**SECTION 96(1A) MODIFICATION APPLICATION
Four Points by Sheraton Hotel Redevelopment
161 Sussex Street, Sydney
(SSD 4972 MOD 2)**

Secretary's Environmental Assessment Report
Section 96(1A) of the
Environmental Planning and Assessment Act 1979

July 2014

Figure 3: Proposed modified structural columns, trusses and footings design under the tower (South Elevation)

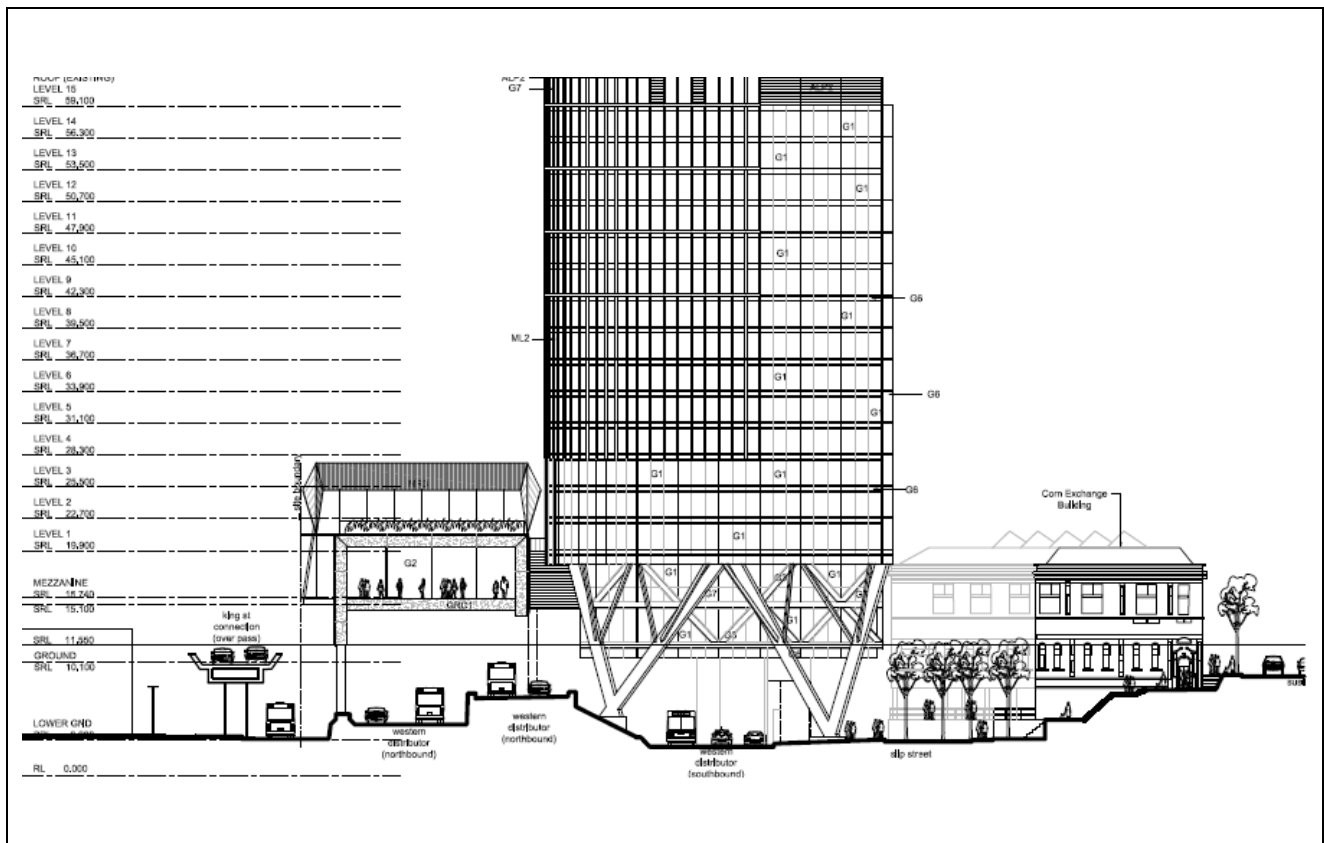
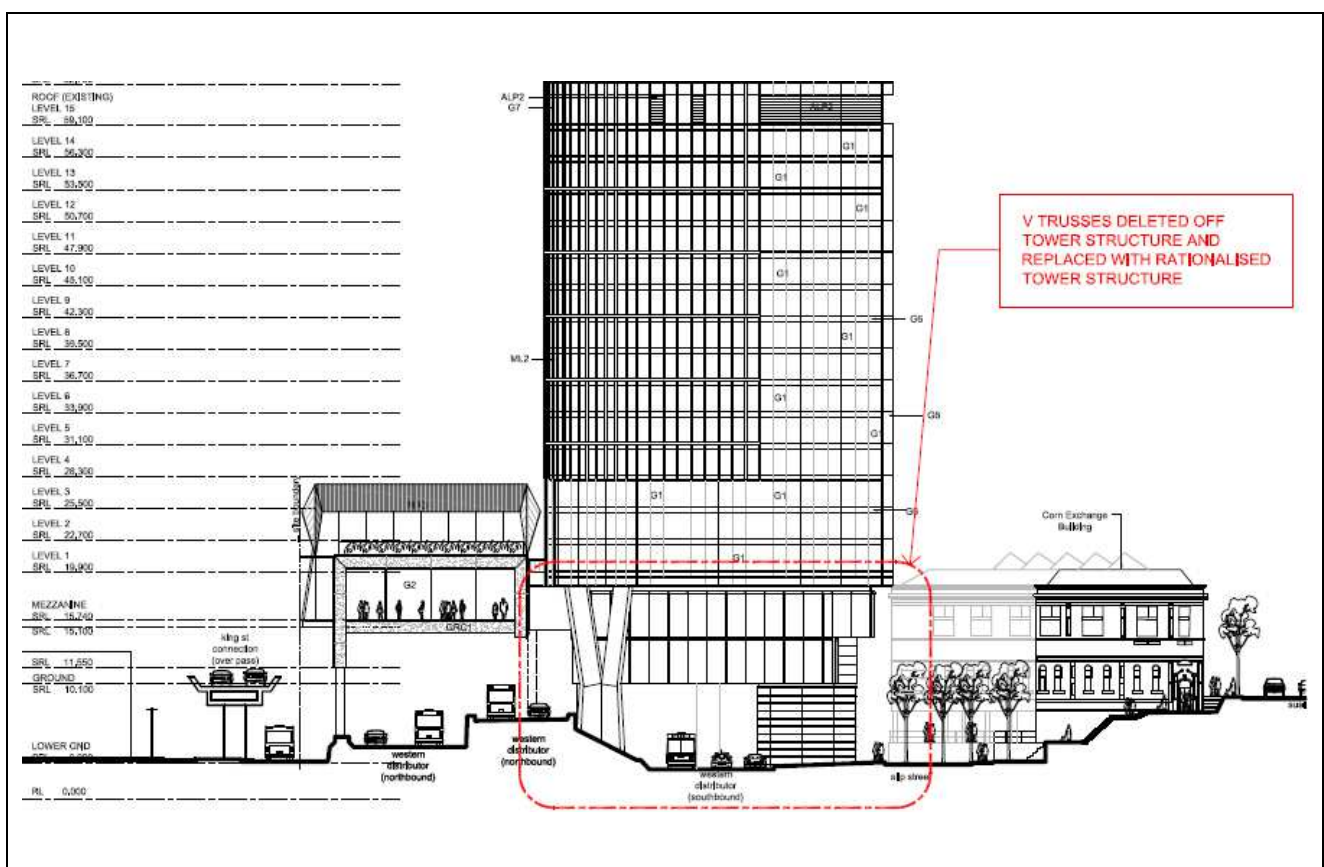
The changes proposed beneath the approved tower comprise the removal of the 'V' column and trusses and replacement with a rationalised structural support system with fewer columns and beams (**Figures 2 and 3**). The revised design also necessitates a minor relocation of the building footings in the median between the Western Distributor northbound and southbound lanes.

Council's submission requested that the department ensure that the external modifications do not further obscure views of the Corn Exchange Building and the Dundee Arms building from Pyrmont Bridge.

Given the proposed changes comprise a simplified structural form with fewer columns and beams, the department considers that the modifications are in fact more likely to enhance views and sightlines from the Pyrmont Bridge. TfNSW raised no issues relating to the potential impacts of the revised structural support system on the Western Distributor or the roads capacity or safety, however, it sought further clarification on potential impacts on the future CBD rail link corridor (refer to **Section 5.2** for further consideration of this issue).

The department is satisfied that the proposed changes to the structural support system beneath the tower would provide an outcome generally consistent with the approved development, and that the changes would not give rise to any issues affecting the design of the road, its capacity or road safety. TfNSW has also confirmed it has no issues with the revised structural support system.

The department therefore considers the proposed changes to the structural support system beneath the approved tower to be acceptable.

Figure 5: Proposed modified structural columns, trusses and footings design under the convention/function space and removal of 4 trees (Lower Ground Level)

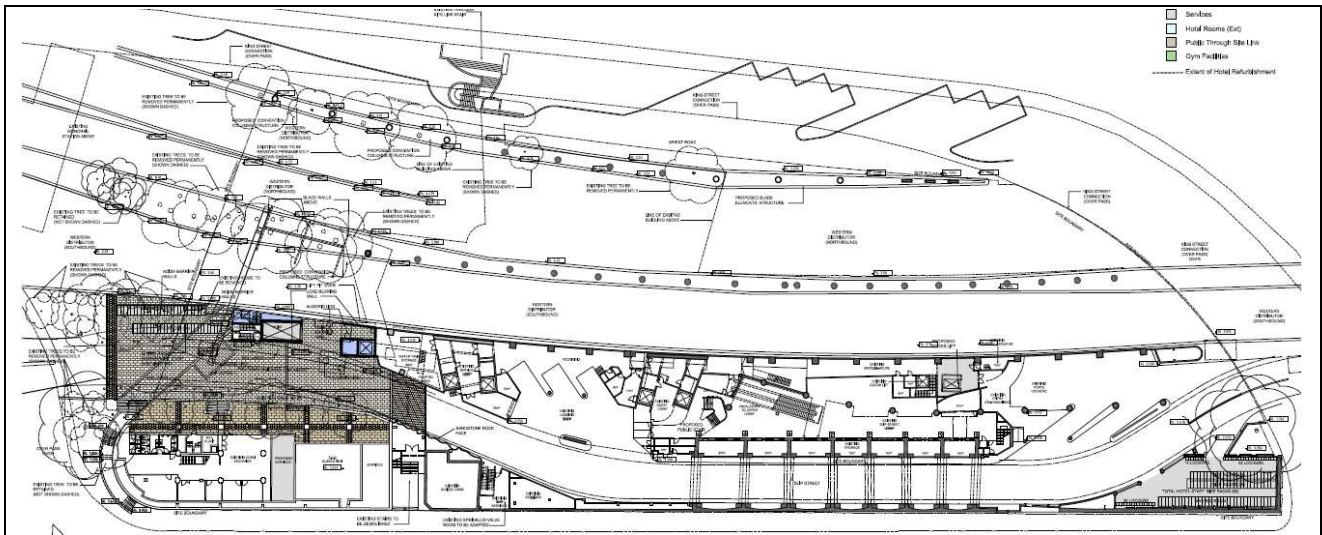
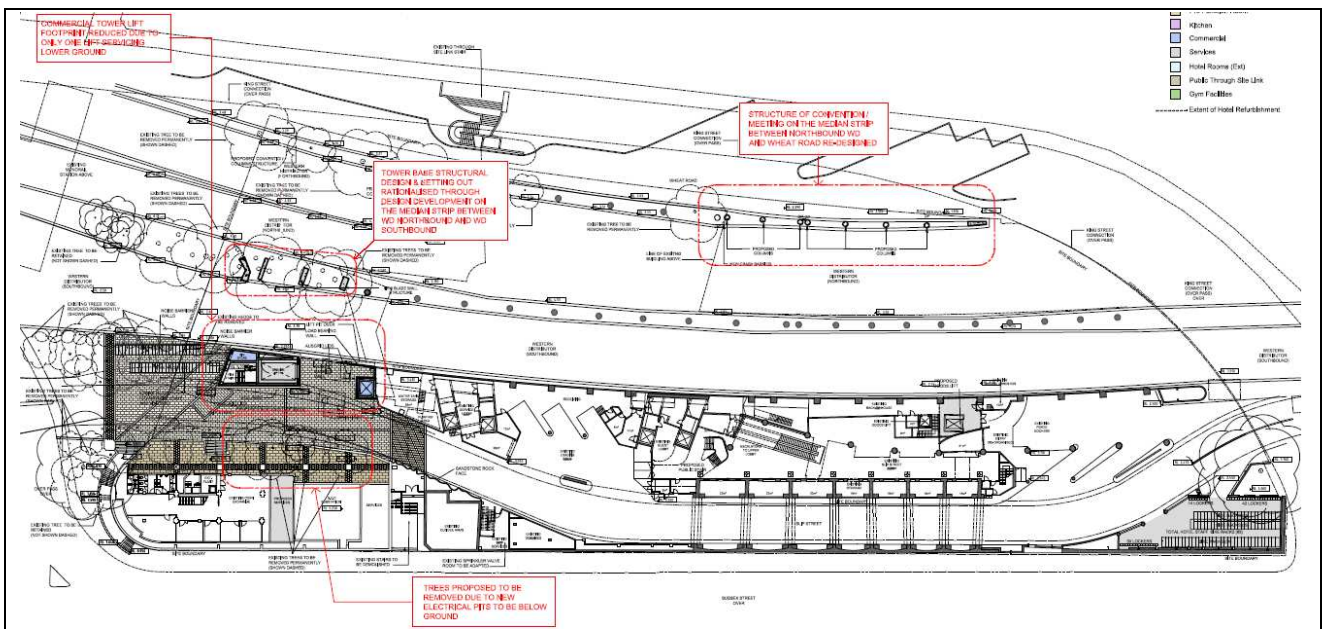
The changes proposed beneath the approved convention/function space comprise the addition of five new structural columns to be located along the median strip between Wheat Road and the north bound Western Distributor (**Figures 4 and 5**). The applicant advised that the changes are the result of a structural and engineering review of the approved design which identified a need for the additional support columns.

No issues were raised by any agencies or council in relation to the changes proposed beneath the approved convention/function space, and TfNSW raised no issues relating to any impacts on the Western Distributor, road capacity or safety (notwithstanding its initial concerns raised regarding the potential impacts on the future CBD rail link corridor which are discussed further in **Section 5.2**).

The department notes that the new columns would be adjacent to the existing approved columns and that they would provide an outcome generally consistent with the approved development, and they would largely be obscured from view from Darling Harbour. Additionally, as outlined earlier, should the proposed modification be approved, the revised structural support system will also be required to satisfy the conditions relating the provision of detailed drawings, geotechnical reports, and the mitigation of road traffic noise associated with the Western Distributor.

The department therefore considers the proposed changes to the structural support system beneath the approved convention/function space to be acceptable.

Figure 7: Proposed deletion of pre-function area and replacement with smaller meeting room (Ground Level)

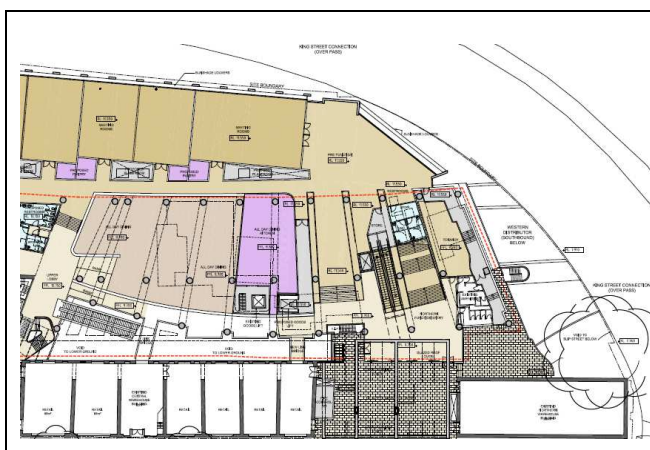
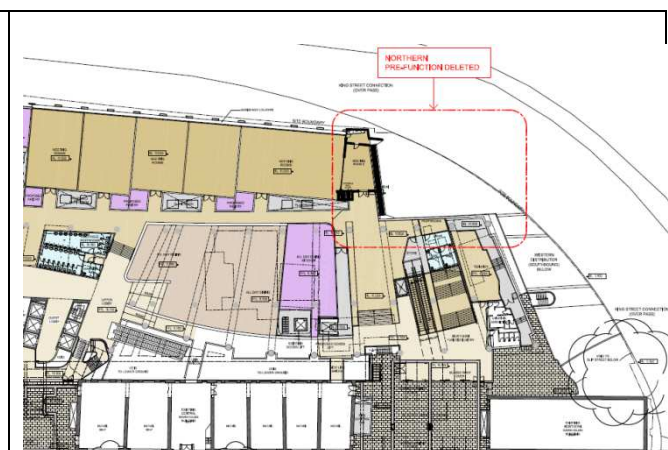
The modification application includes the removal of the pre-function area, situated in the building's north-west corner, and its replacement with a smaller meeting room (**Figures 6 and 7**). The applicant advised that:

The department notes that the proposed changes would result in a reduction in floor space of 300 m² and a minor change to the building's appearance when viewed from the north and west. The main change to the building's appearance relates to the removal of the shading fins from the north-west corner, which would be replaced with a predominantly glazed façade.

The department does not object to the proposed changes, and considers that the design changes are minor in the context of the overall development.

Figure 9: Proposed modified lift core and commercial lobby area (Level 1)

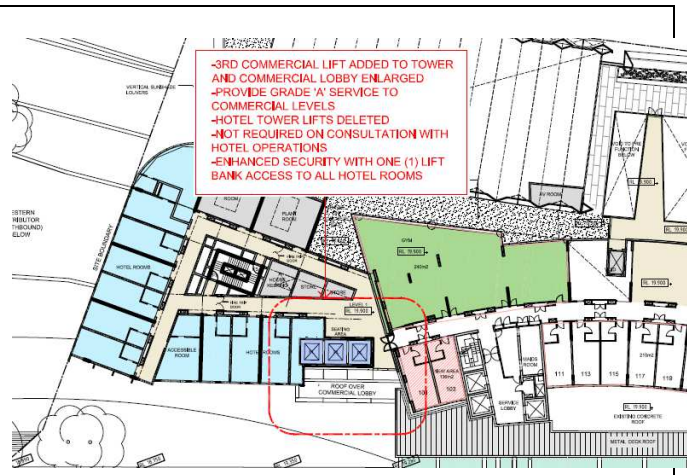
The application proposes rationalisation to the lift core from four to three lifts and minor changes to layout of the commercial lobby area for each level of the hotel (**Figures 8 and 9**).

The proposed changes are minor in nature and they would not compromise the functionality of the building as the existing lifts would be utilised to service the existing and some of the new hotel area in the tower. The department is therefore supportive of the proposed internal changes.
